**PLANNING & ZONING**  
**February 06, 2025**  
**5:30 PM**  
**City Hall**

### **MILLS CITY PLANNING COMMISSION**

## **Lots 2A & 3A, Sage Addition**

**Vinich Development  
Commercial Development Plan**

**C1.0**

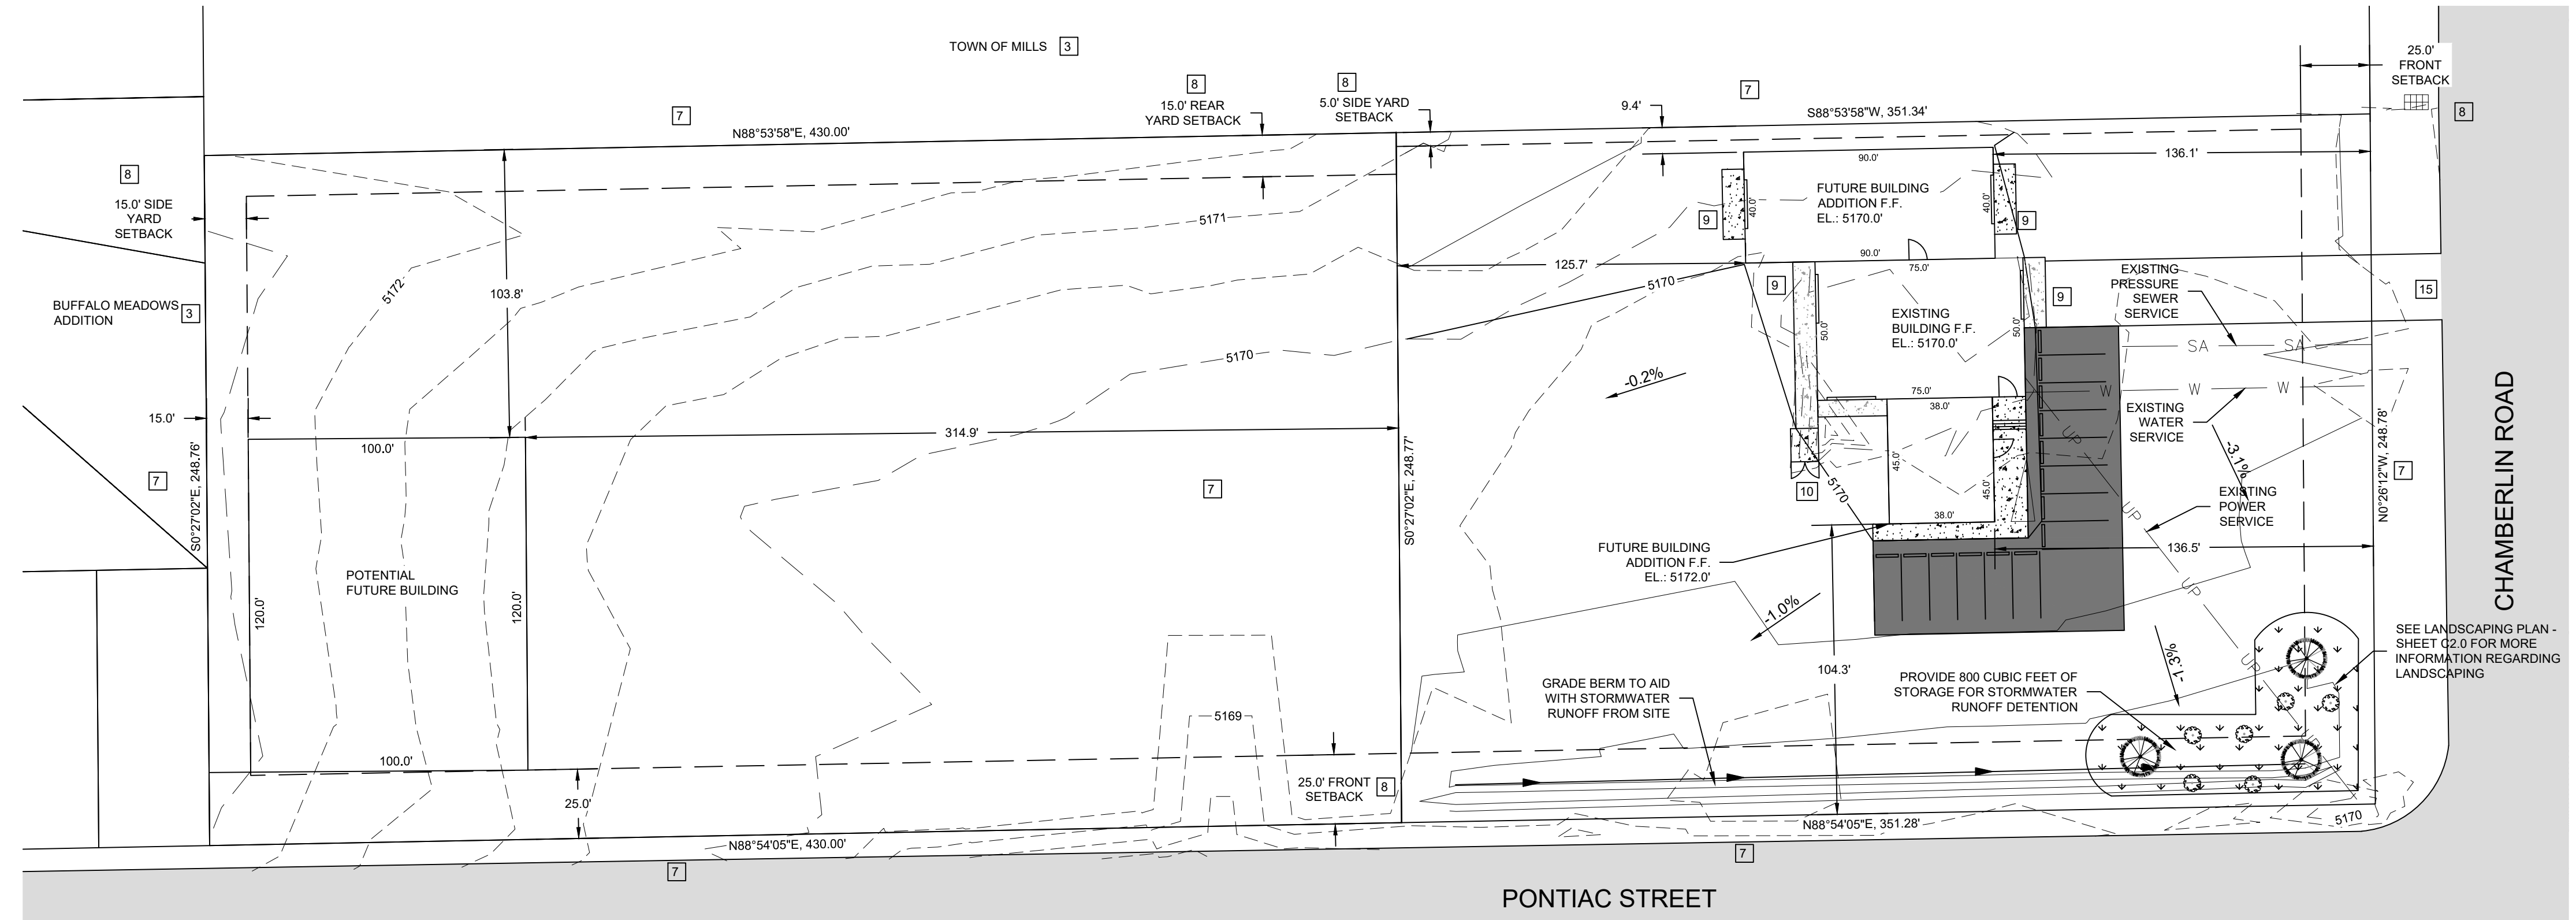
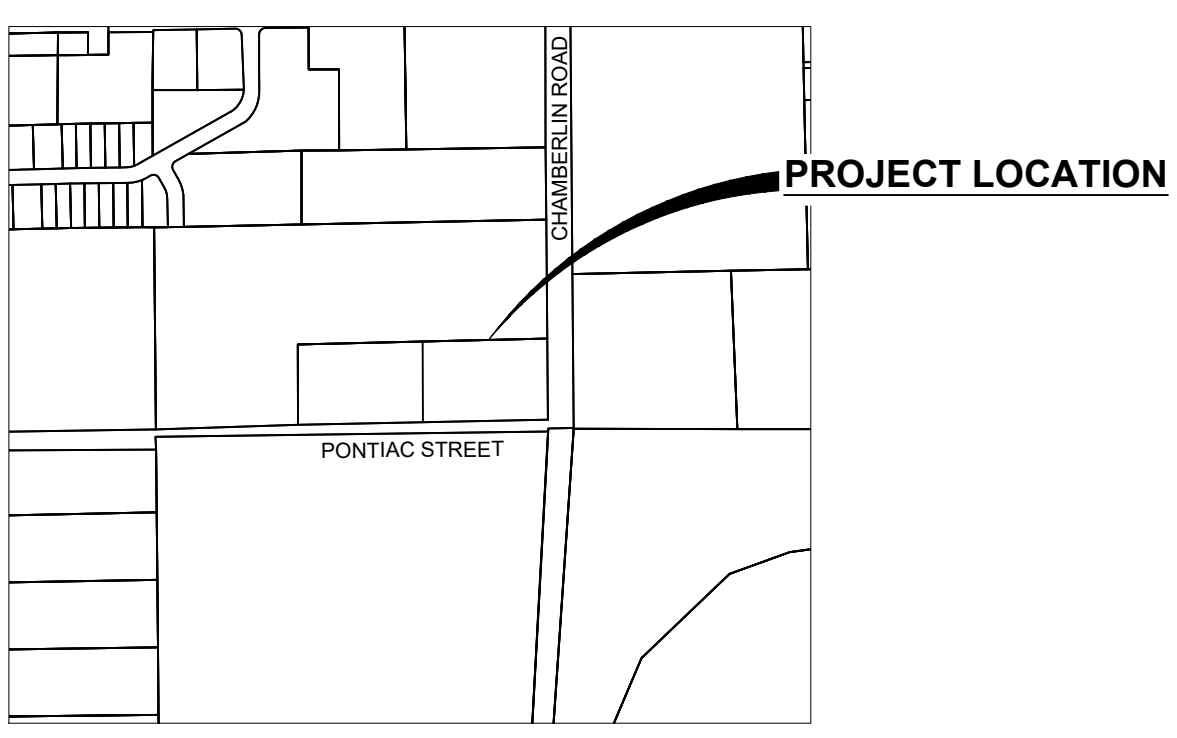
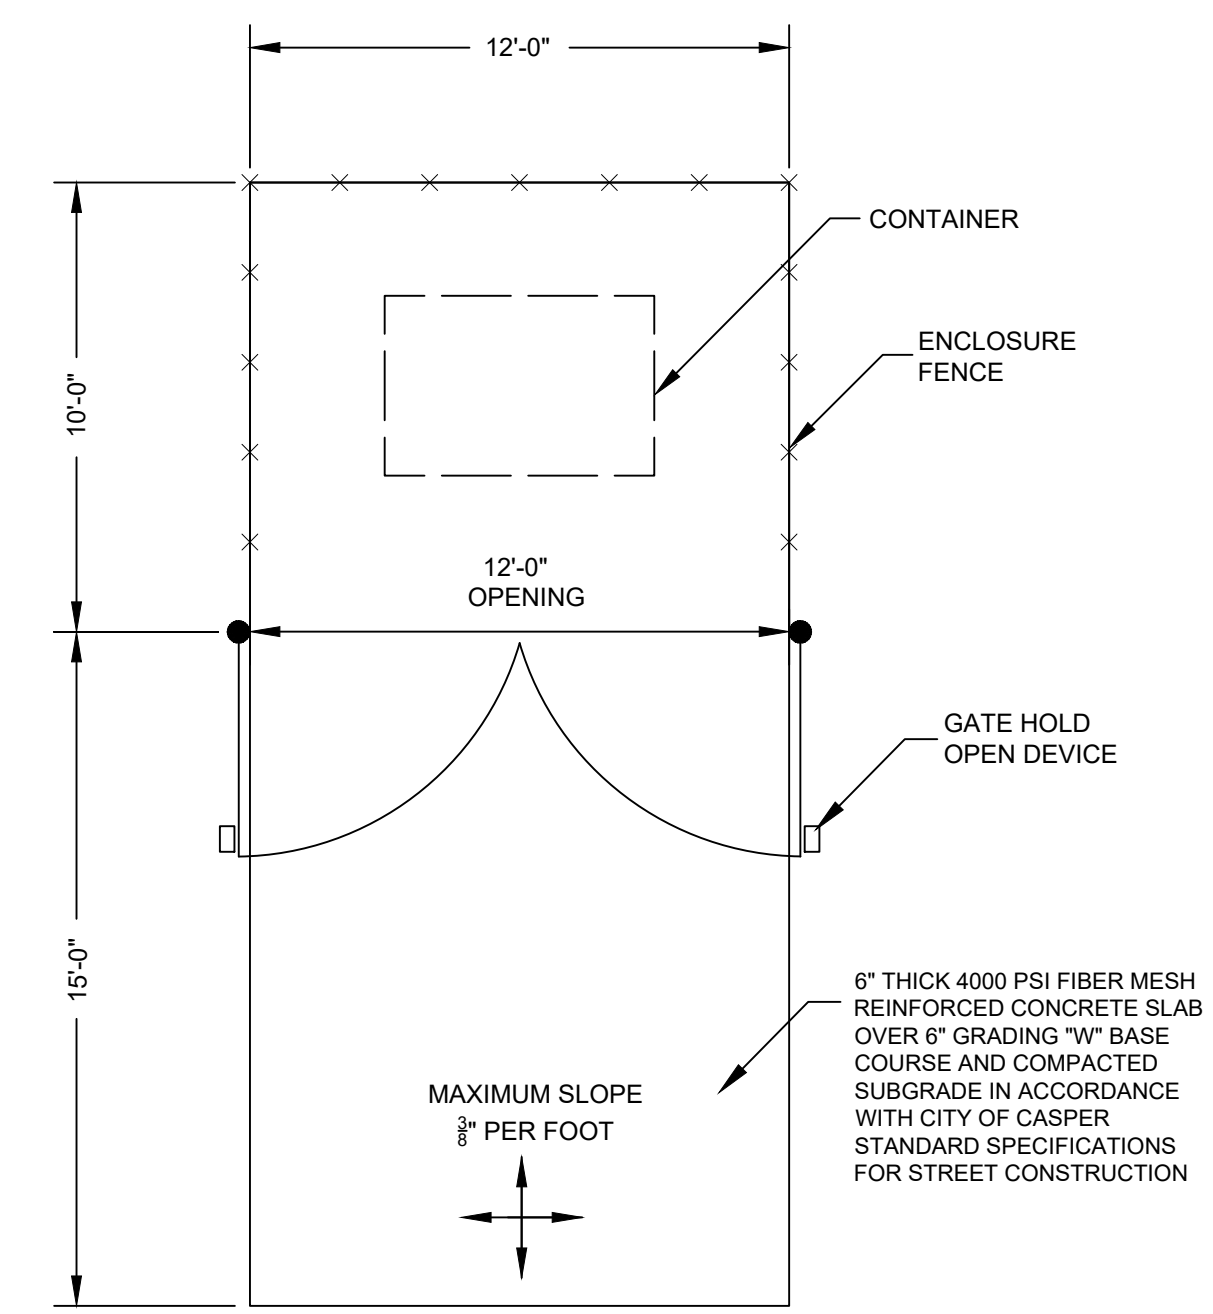
plan for the property has been included with the submittal. The development plan notes th  
exterior lighting will be on the building, with no proposed parking lot illumination...  
Specifications for the types of exterior lighting for the building need to be provided.

A 'potential future building' is depicted on the adjacent Lot 3A. It should be noted that any future development on Lot 3A will require a separate Development Plan application and review. The applicant should also be aware of additional setbacks and buffering that will be required for commercial or industrial development adjacent to the residential Buffalo Meadows Addition.

1. Submit an exterior lighting plan per Section 40.35(4) showing the location and types of lighting for the building, along with manufacturer's specifications.
2. Per Section 40.10(6) all required parking spaces and all driveways, entrances and exits from the parking area shall be paved with asphalt, concrete or similar permanent surface.
  - a. Nine (9) parking spaces are required. 14 are shown on the development plan with asphalt surfacing. This meets the intent of the regulations.
3. Submit a final drainage plan
4. Enter into an approved Site Plan Agreement upon approval of the Development Plan.
5. Obtain all required building permits for:
  - a. All site lighting
  - b. All on-premise signage.

# LANDSCAPE PLAN FOR LOTS 2 AND 3, SAGE ADDITION

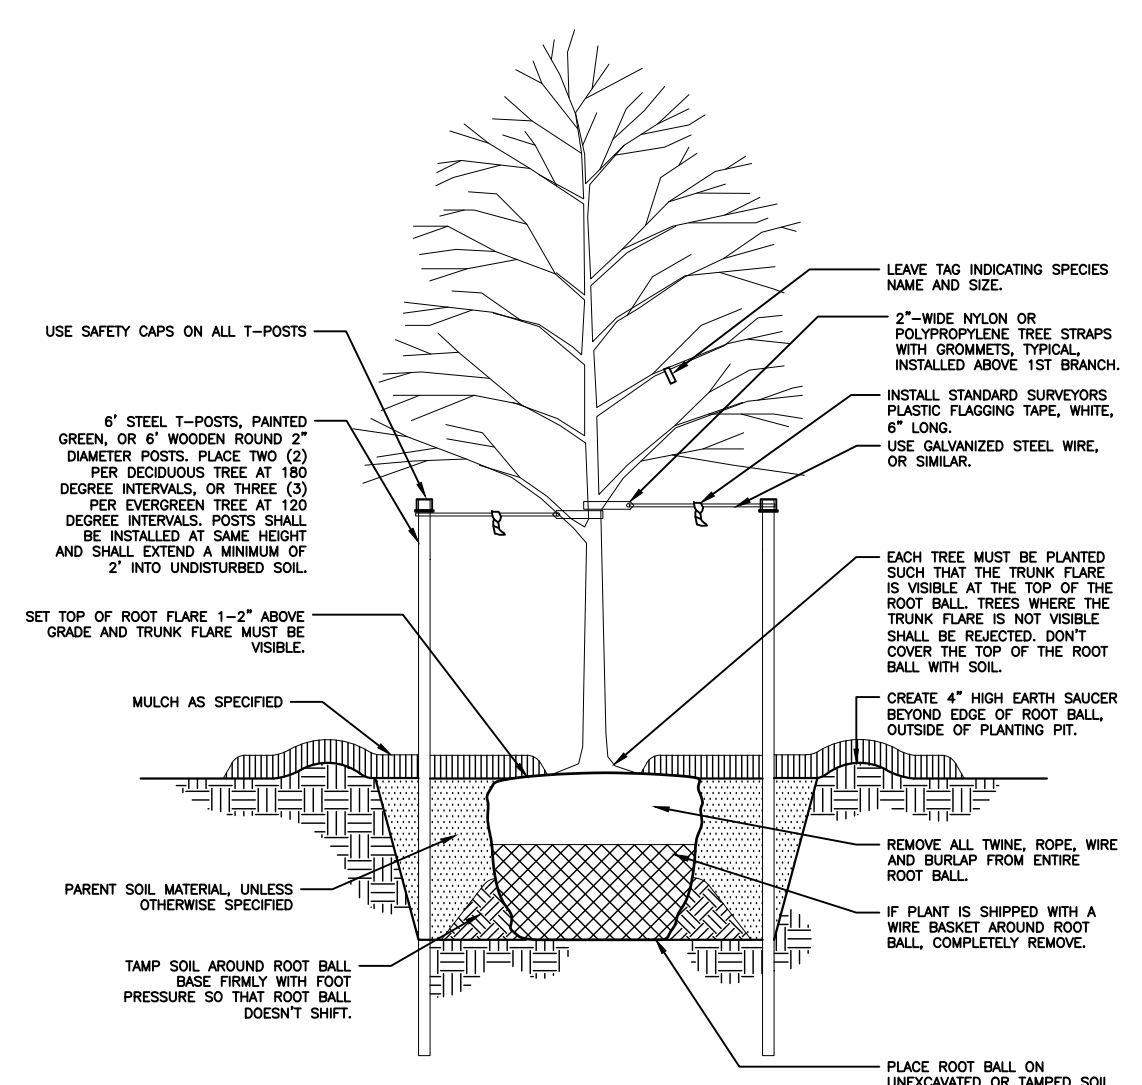
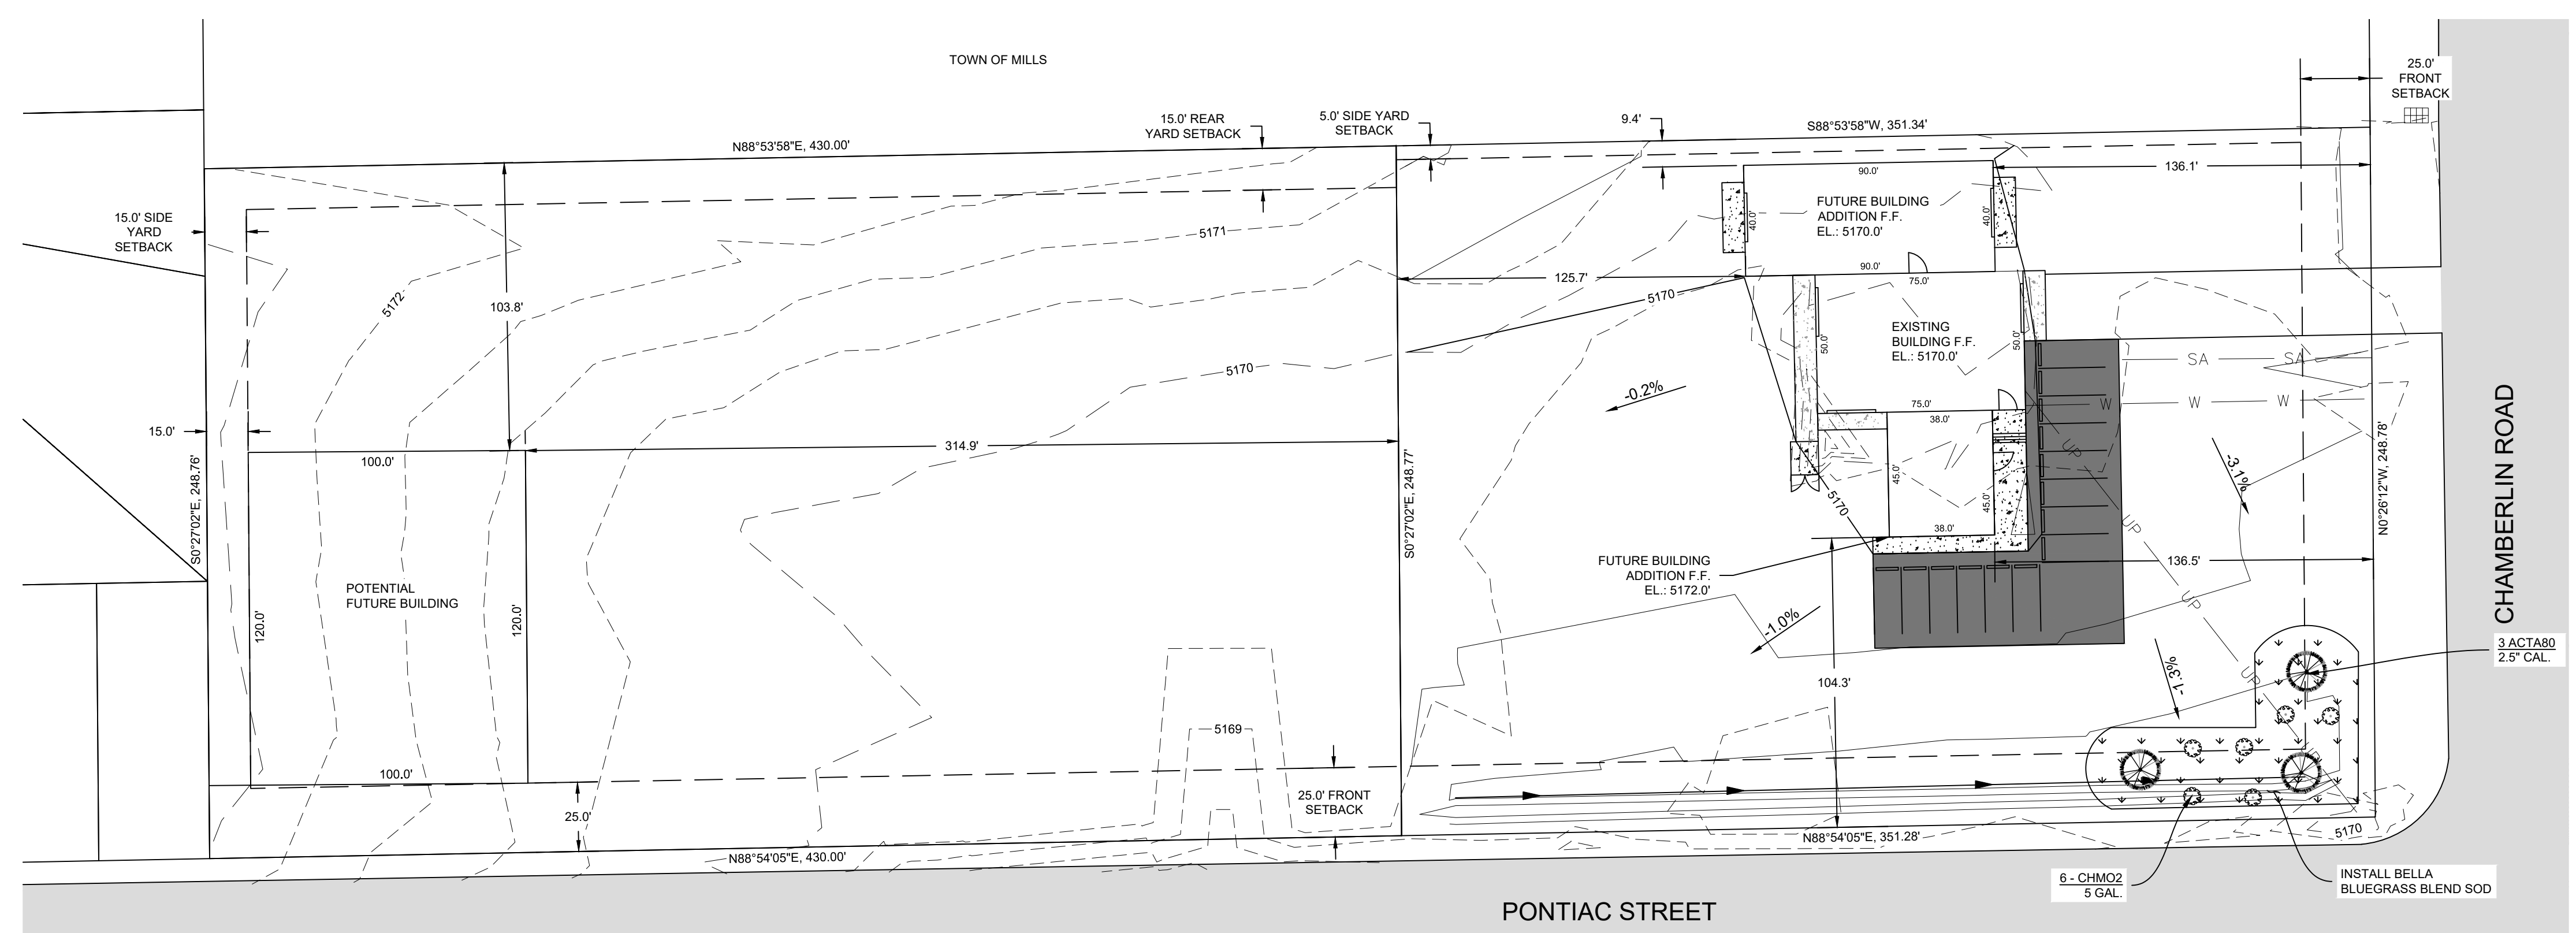
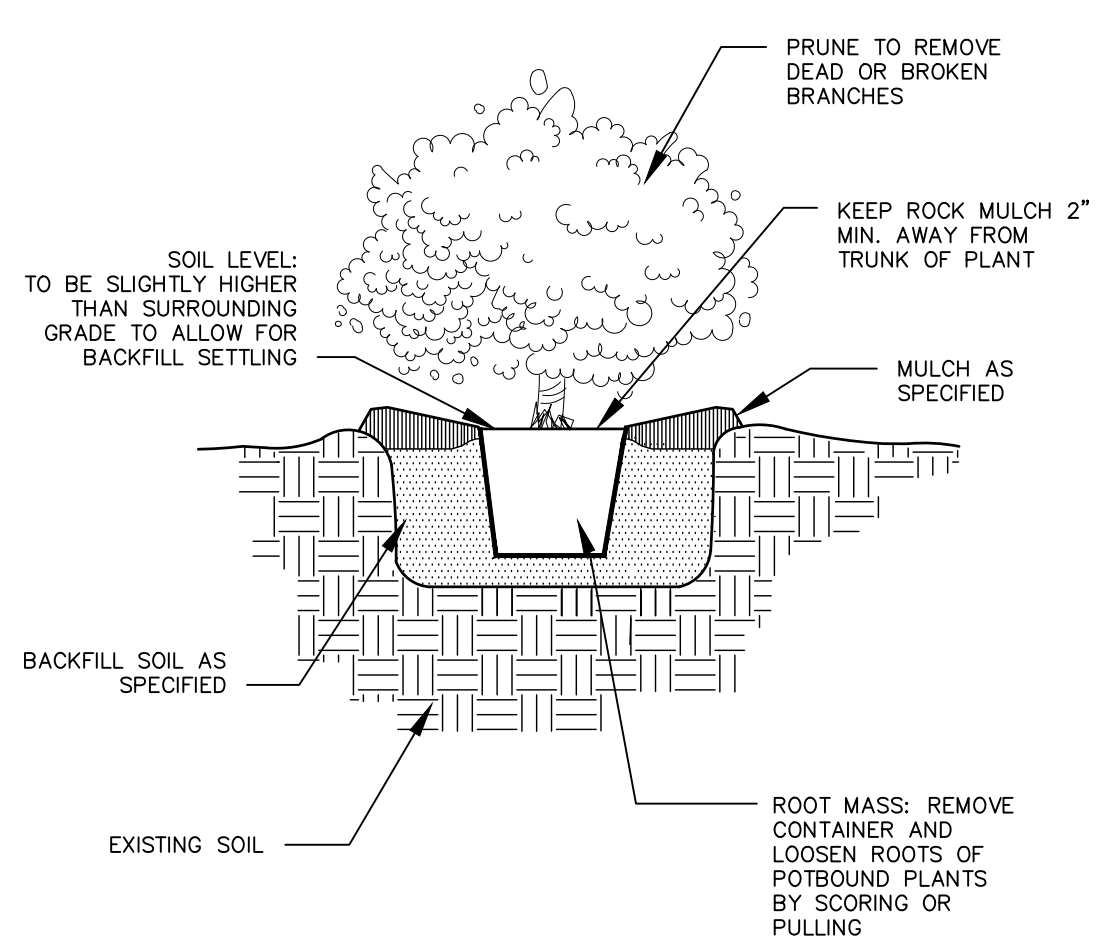
Per Section 40.40 of the LDRs, a minimum of 8 of the site must be landscaped. A landscaping
